Access Compliance Report

Public Rights-of-Way

| Intersection ID: 3373 | Main Street: KATELYN_DR | Cross Street: PROSPERITY_CHURCH_RD | Location: E |
| ADA ID: 33AE3A32B19E | Ramp Type: Para | Initial Pass/Fail: Fail | Overall Compliance: No |

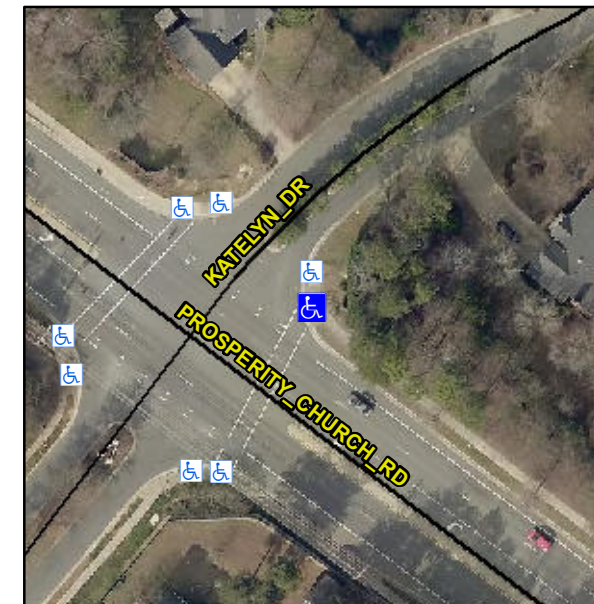
LT RP < 5%

R304.3.2

| Compliance | Description | Data | Compliance | Description | Data |
|------------|----------------------|-------|------------|-----------------------------|------|
| Yes | Ramp Slope LT (%) | 3.5 | No | Ramp Slope RT (%) | 12.5 |

Remove & Replace Entire Ramp.
